RC1: 'Comment on essd-2024-406', Dr. Adrien Paris

RC2: 'Comment on essd-2024-406', Dr. Arnaud Cerbelaud

Fig R. 1. Number of dates with only one measurement relative to the mean discharge of the gauges, shown in all VSs and for each orbit family separately.

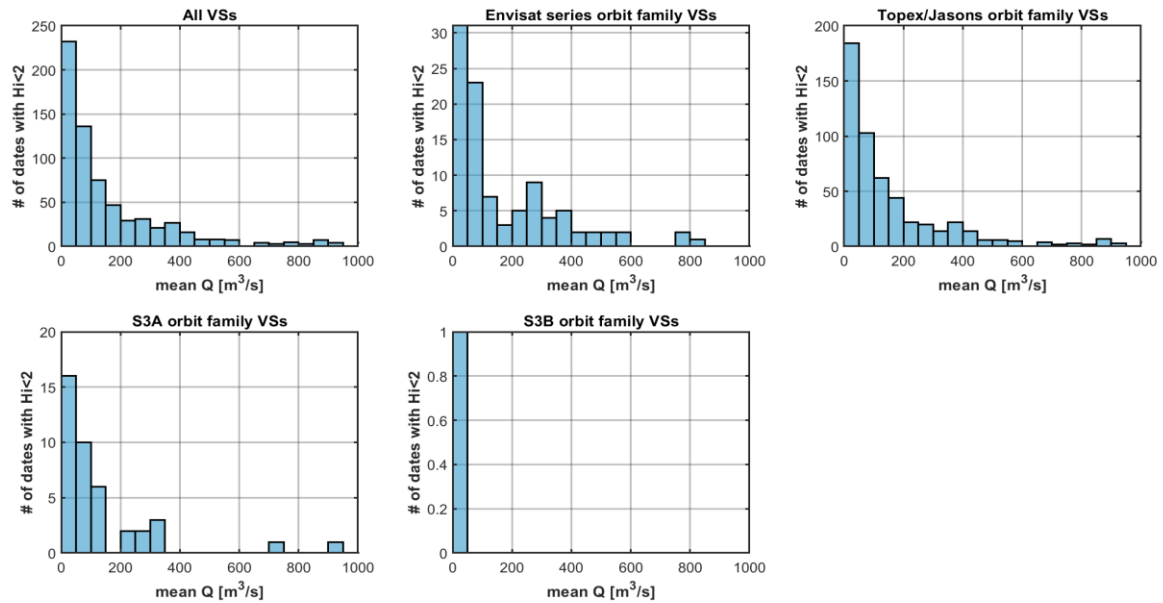
- L152-153: this masking choice implies, for past missions, to keep a very low number of "Hi" measurements from your raw altimetric data. For small rivers, this would mean keeping only the one measurement geolocated over the water. What are your statistics on this point (percentage of dates with <2 H_i measurements for example), and do this have an influence on the final median that you process (and which uncertainty do you provide in this case)? I believe this should be further explained.

Thank you for your comment. We have reviewed our data processing to address your concerns. Our analysis indicates that epochs with fewer than two valid "Hi" measurements occur in only 0.6% of the total data epochs, which is consistent across orbit families: approximately 0.2% in the Envisat series, 0.8% in the Topex/Jason series, 0.2% in Sentinel-3A, and only one case in Sentinel-3B. Figure R1 demonstrates the number of dates with only one valid measurement relative to the mean discharge of the gauges, shown in total and for each orbit family separately. As expected, these cases are more frequent in narrower rivers but remain insignificant in terms of the total number of epochs.

For epochs with only one valid "Hi" measurement, we retain the measurement as it represents an aggregated value derived from multiple echoes. With the 75% water occurrence threshold applied, the level of noise is significantly reduced, and we consider the resulting water level estimate reliable. We have added the following explanation to the revised manuscript for clarity:

“The use of the GSW mask helps maintain the quality of the extracted time series by excluding non-water reflections. Cases with fewer than two valid measurements per epoch are rare (0.6% of all data epochs) and are retained.”
